December 19, 2022

ADDENDUM NUMBER ONE (1)

Project: Tippah County Hospital  
EMS Building  
PN: 22005

FROM: Dean Architecture, P.A.  
661 Sunnybrook Road, Suite 140  
Ridgeland, MS 39157  
(601) 939-7717

1  
A901  
FINISH PLAN  
SCALE : 1/4" = 1'-0"

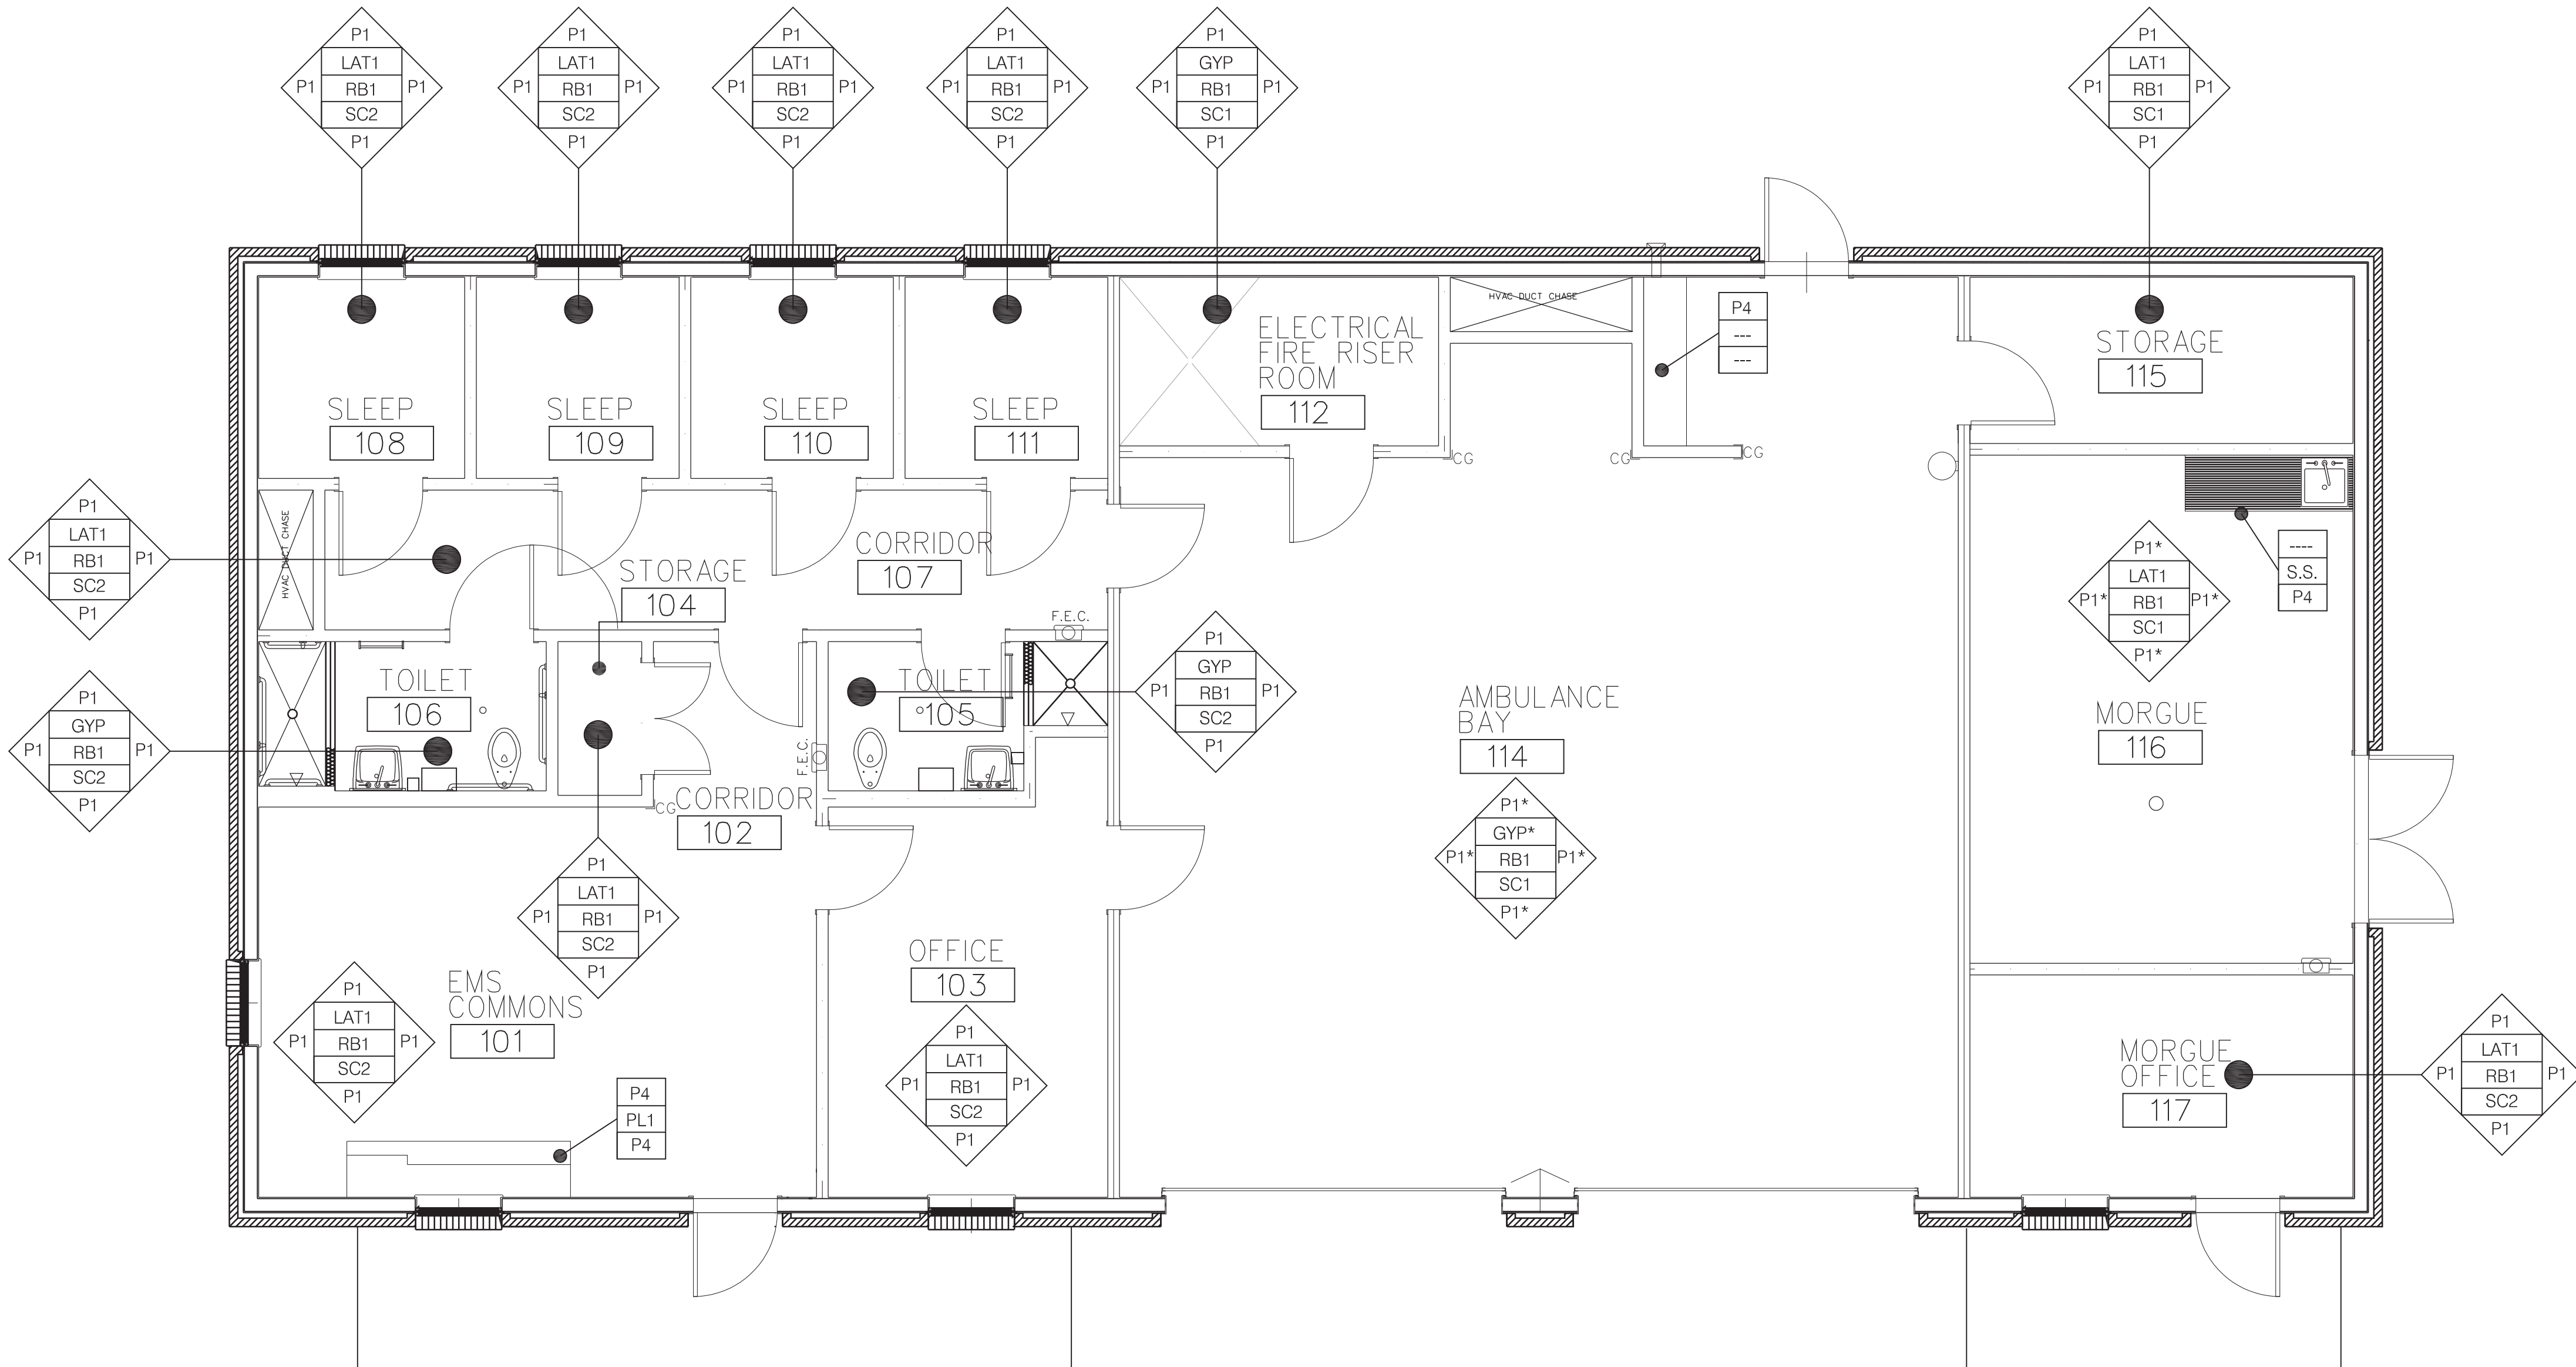
- Item #1:** Add sheet A201-A, Alternate Building Elevation dated Dec 19, 2022 to the bid documents.
- Item #2:** Sheet A901 – remove reference to plastic laminate cabinet finishes and change to painted birch cabinets per specifications section 064100. See revised Sheet A901 attached.

Overall Plumbing Plan

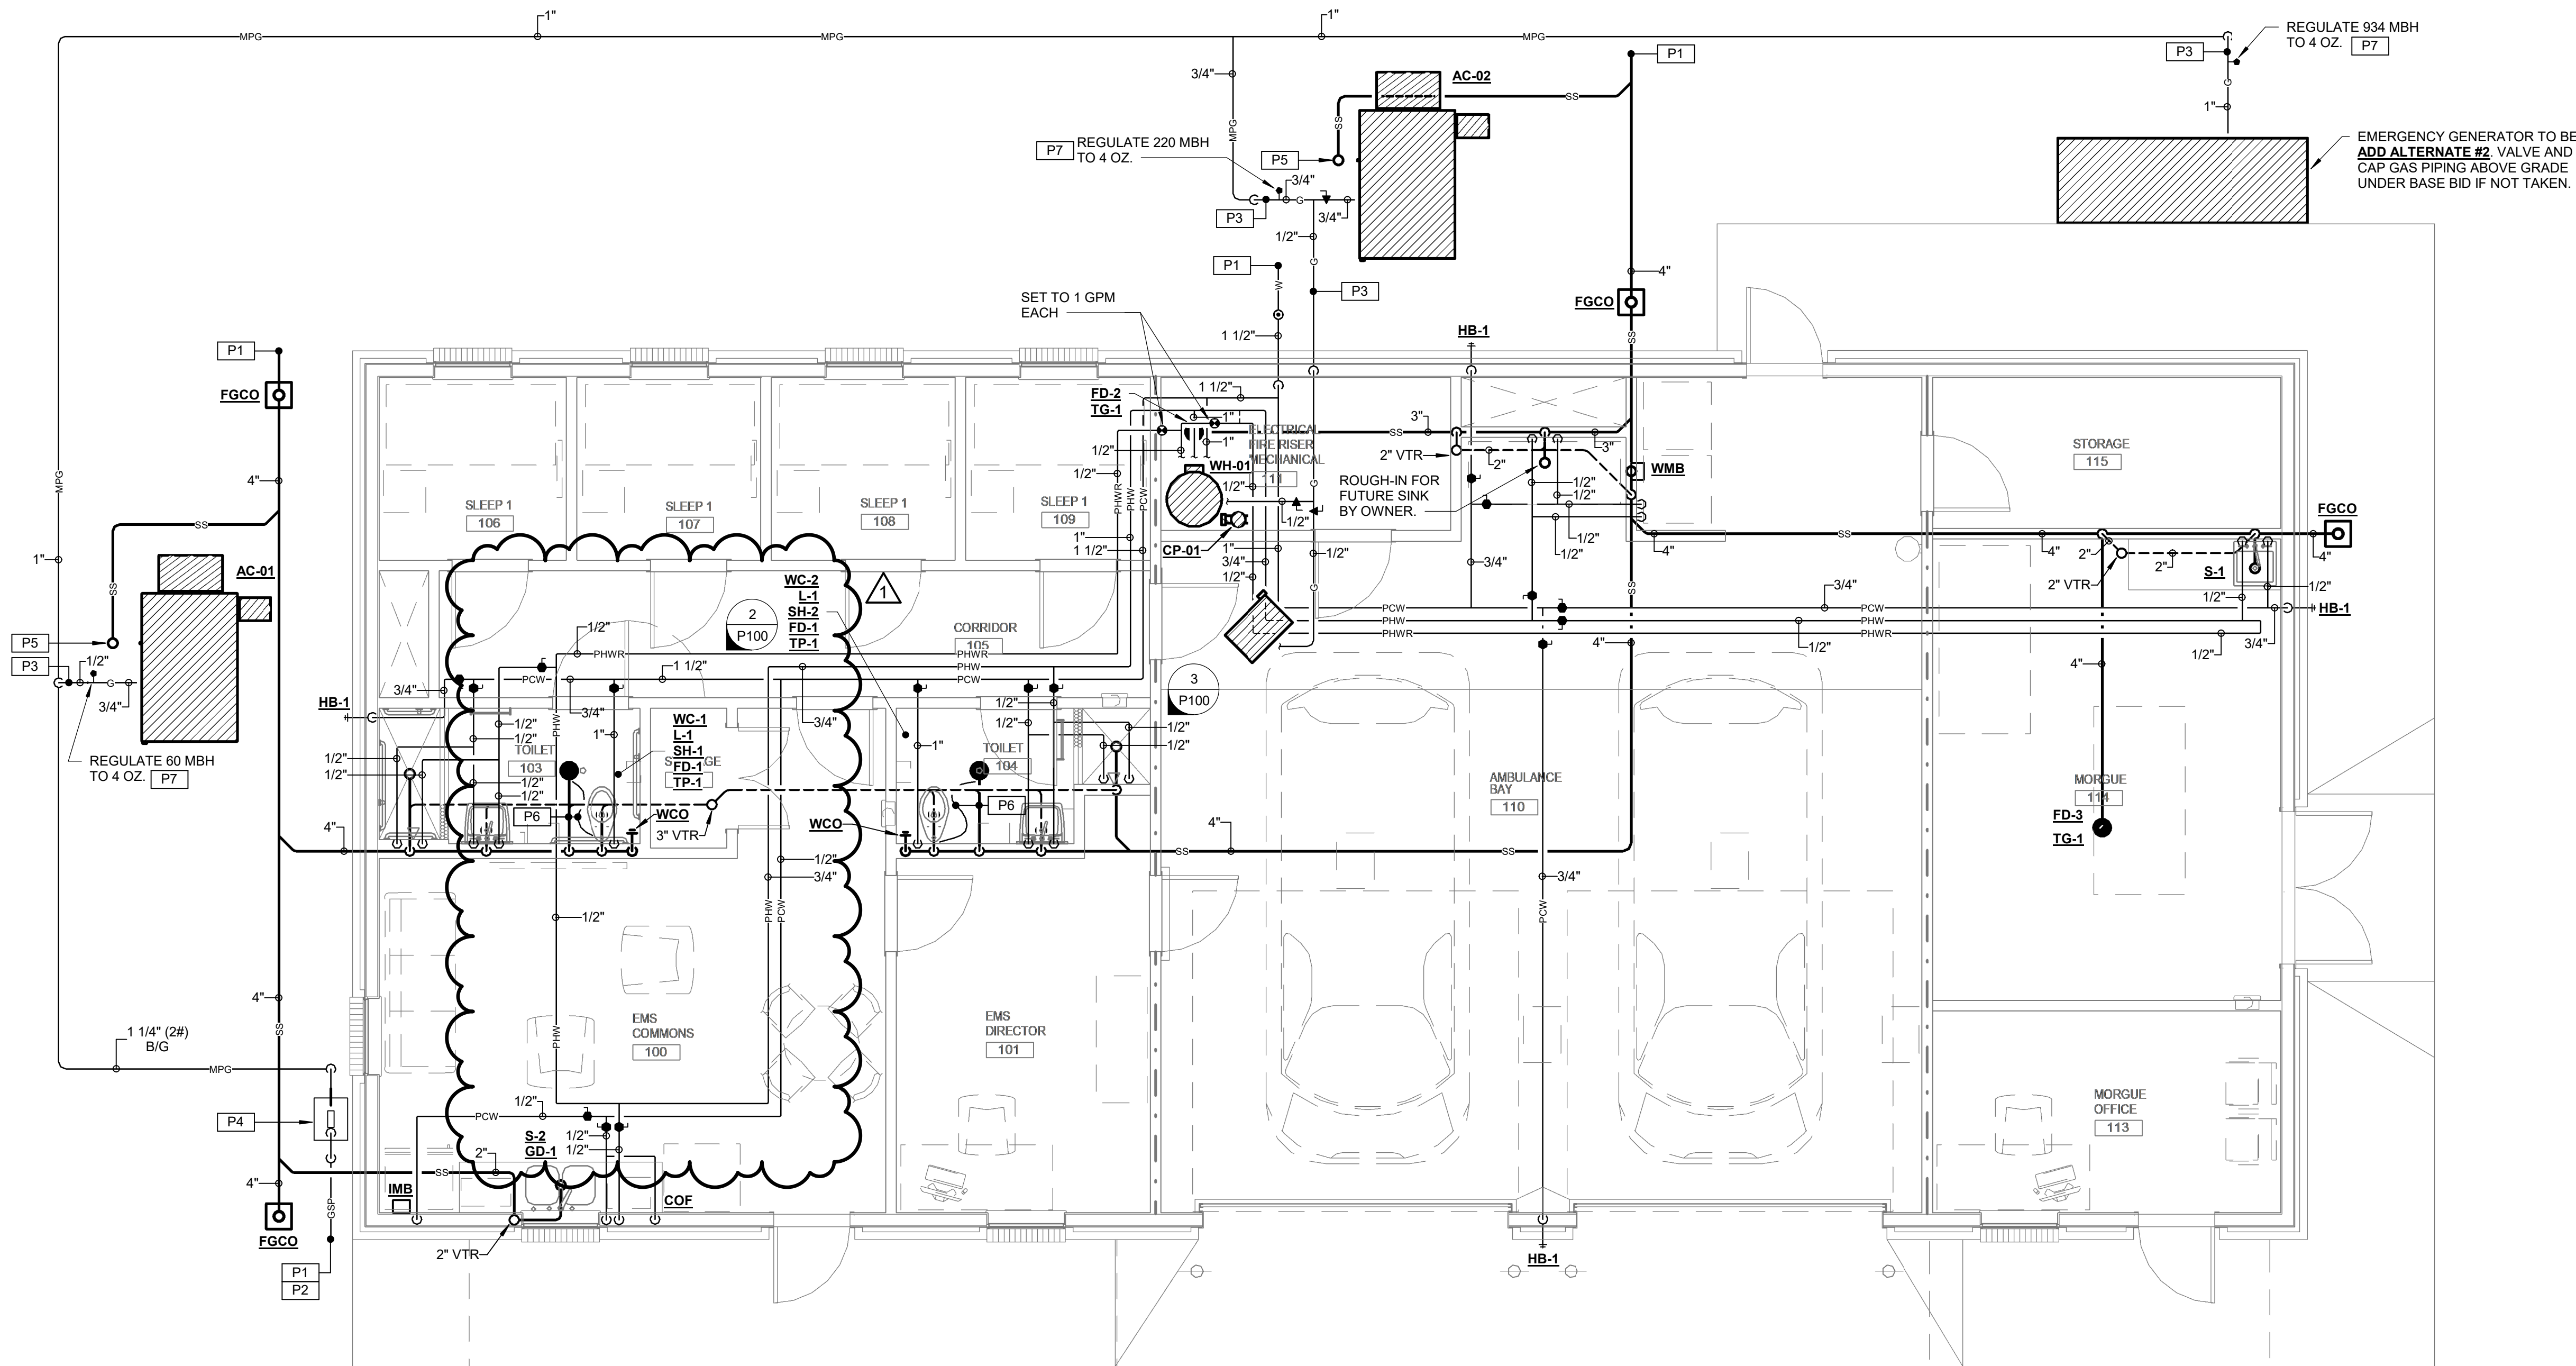
1. Sheet P100 - Delete entire sheet and replace with attached. Changes made included the following:
  - a. Re-routed domestic hot water and domestic hot water return piping transition.
  - b. Added ball valves to domestic hot and domestic cold water piping in 'EMS Commons 100' area.
2. Sheet P200 - Delete entire sheet and replace with attached. Changes made included the following:
  - a. Corrected WH-01 'Electrical Service' value on 'Domestic Water Heater Schedule'.
3. Sheet P300 - Delete entire sheet and replace with attached. Changes made included the following:
  - a. Added details.
4. Sheet M300 - Delete entire sheet and replace with attached. Changes made included the following:
  - a. Added Details.

1 SITE PLAN - ELECTRICAL  
E101 SCALE: 1"=10'-0"

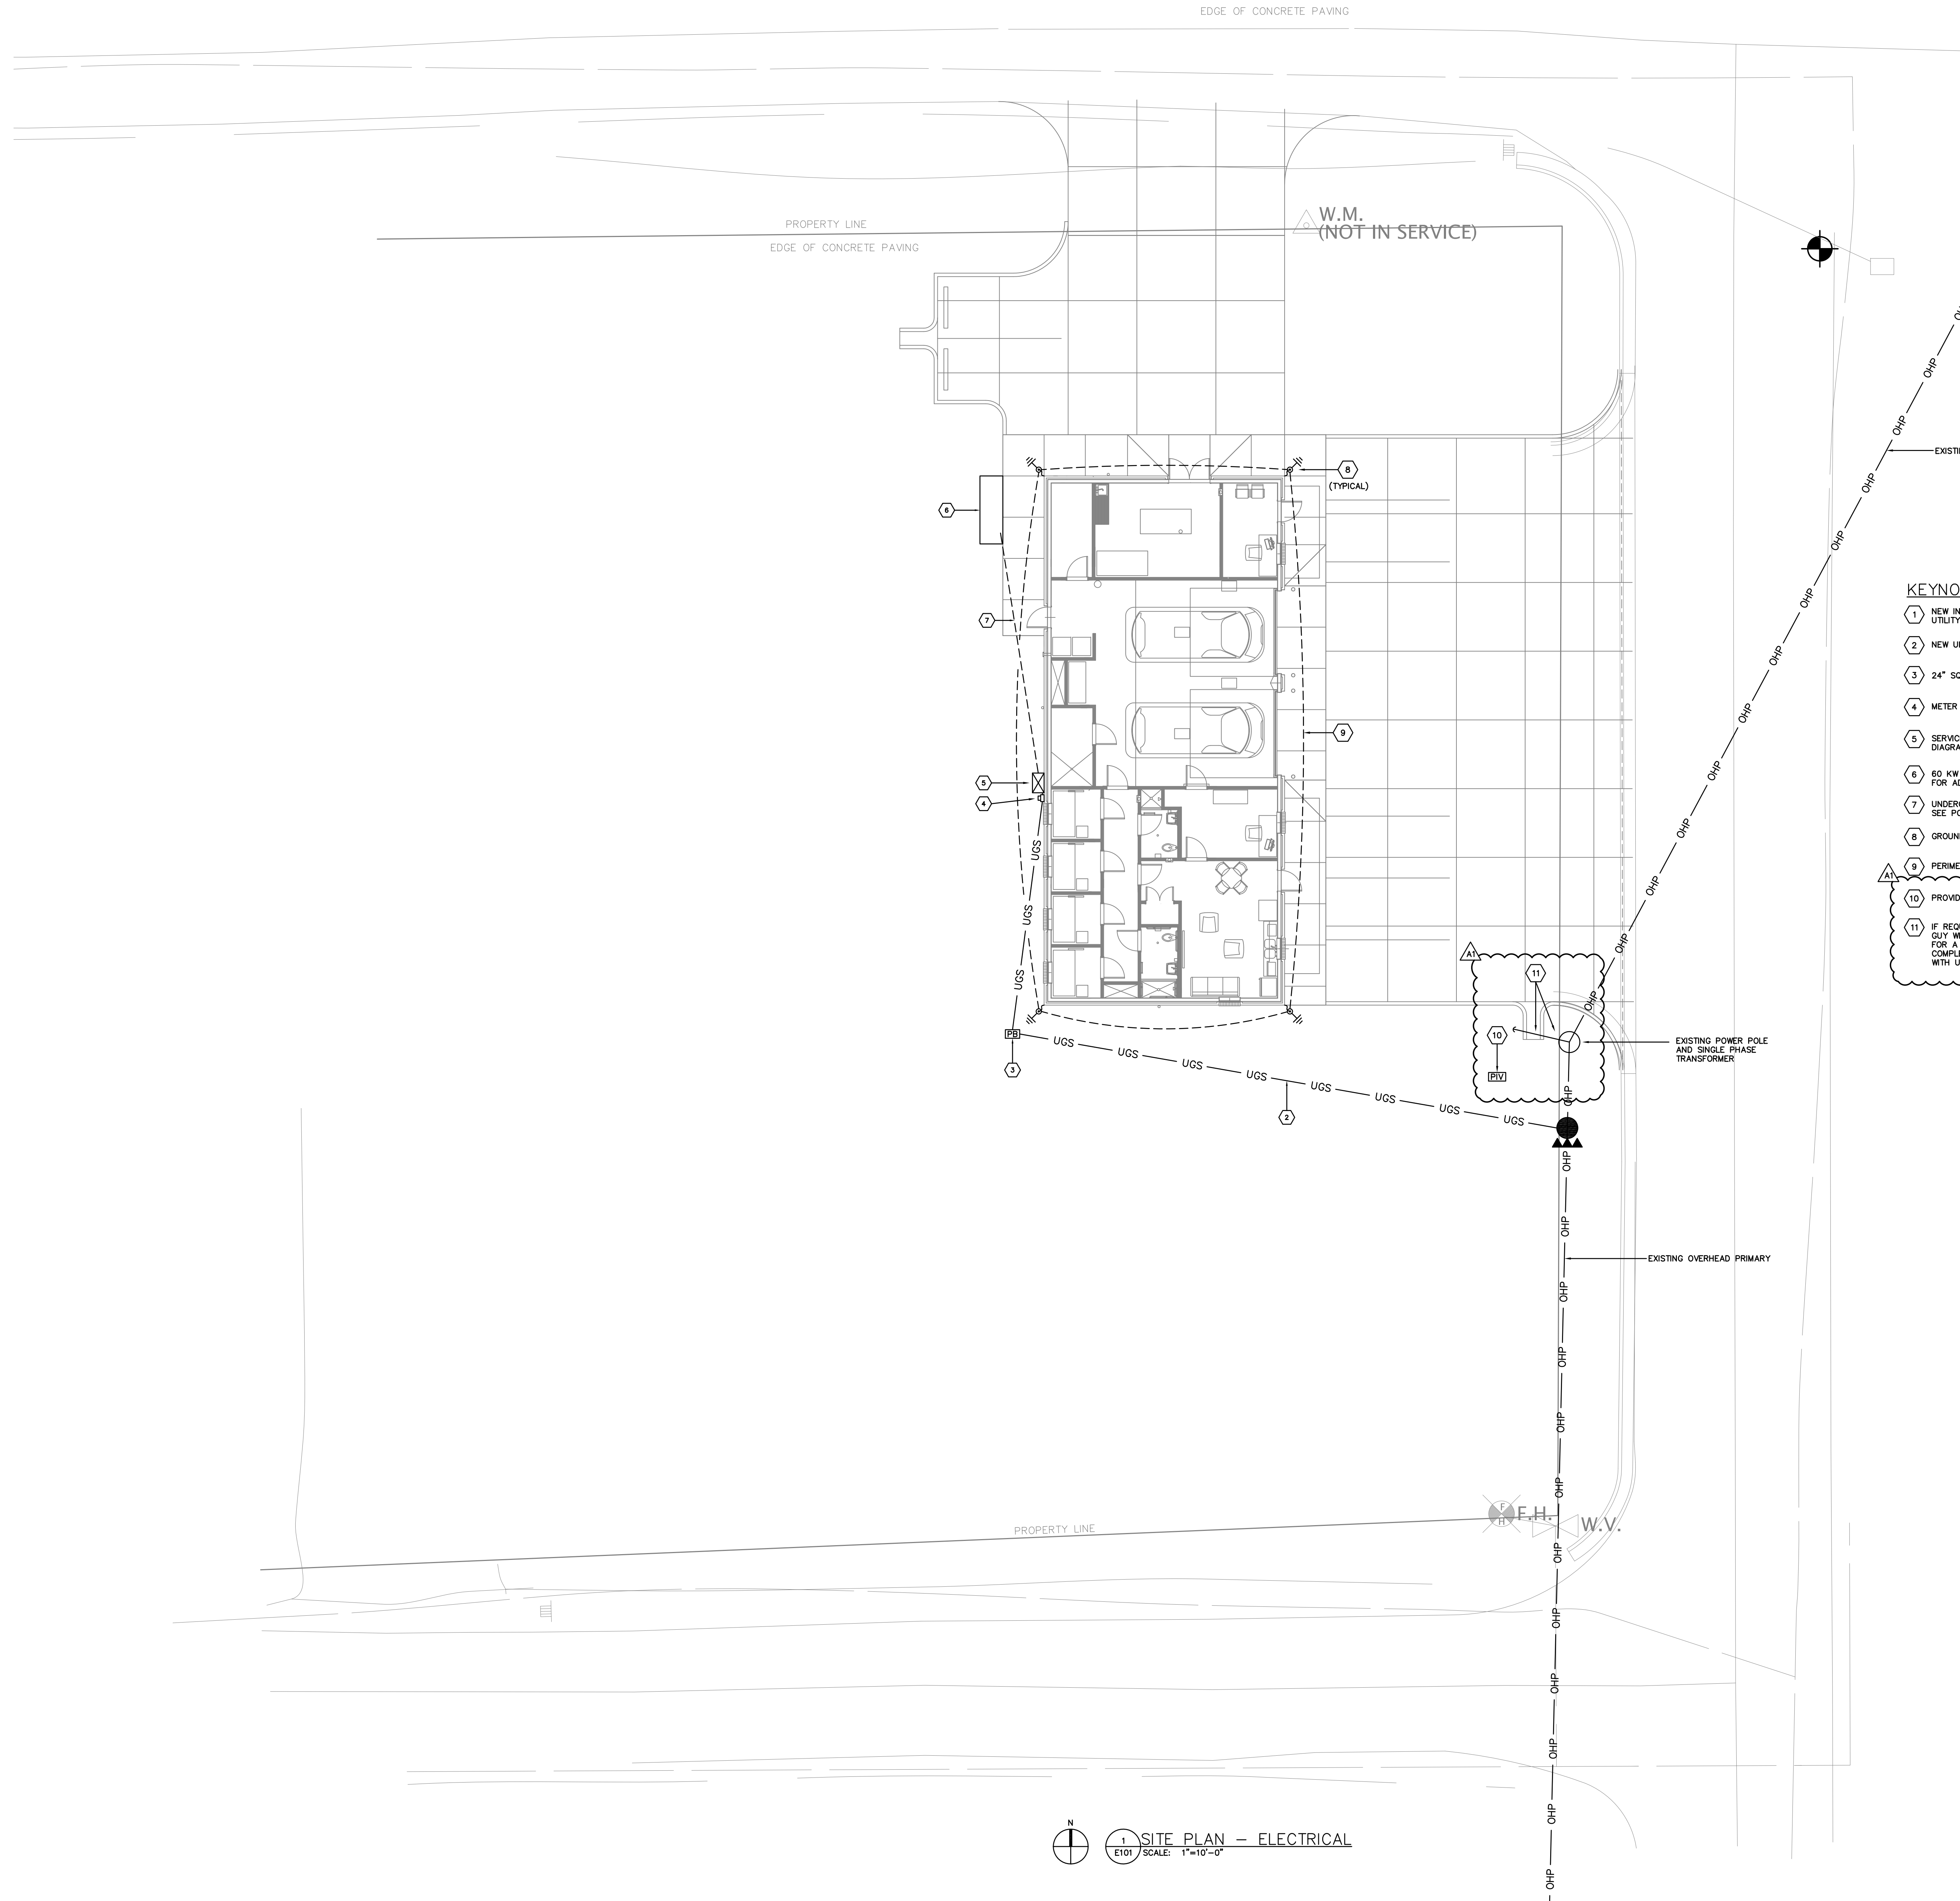
1. There is an existing utility company power pole that cannot be relocated that has a guy wire that may interfere with construction of the concrete flume for drainage. If required, provide a new guy wire so that the original guy wire can be temporarily removed to pour concrete. Once concrete work is complete, re-install original guy wire. Coordinate work with Utility Company.
2. A post indicator valve for the fire alarm system is shown.

- KEYNOTES**
- 1 NEW INLINE DIP POLE AND THREE PHASE TRANSFORMER BANK BY UTILITY COMPANY.
  - 2 NEW UNDERGROUND SECONDARY. SEE POWER RISER DIAGRAM.
  - 3 24" SQUARE IN-GRADE PULL BOX.
  - 4 METER BASE. SEE POWER RISER DIAGRAM.
  - 5 SERVICE RATED AUTOMATIC TRANSFER SWITCH. SEE POWER RISER DIAGRAM.
  - 6 60 KW GENERATOR. SEE POWER RISER DIAGRAM AND SHEET E201 FOR ADDITIONAL REQUIREMENTS.
  - 7 UNDERGROUND FEEDER FROM GENERATOR TO TRANSFER SWITCH. SEE POWER RISER DIAGRAM.
  - 8 GROUND ROD.
  - 9 PERIMETER GROUND LOOP. SEE SPECIFICATIONS.
  - 10 PROVIDE FIRE ALARM CONNECTION TO POST INDICATOR VALVE.
  - 11 IF REQUIRED, PROVIDE A NEW GUY WIRE SO THAT THE ORIGINAL GUY WIRE CAN BE TEMPORARILY REMOVED TO POUR CONCRETE FOR A FLUME FOR DRAINAGE. ONCE THE CONCRETE WORK IS COMPLETE, RE-INSTALL ORIGINAL GUY WIRE. COORDINATE WORK WITH UTILITY COMPANY.
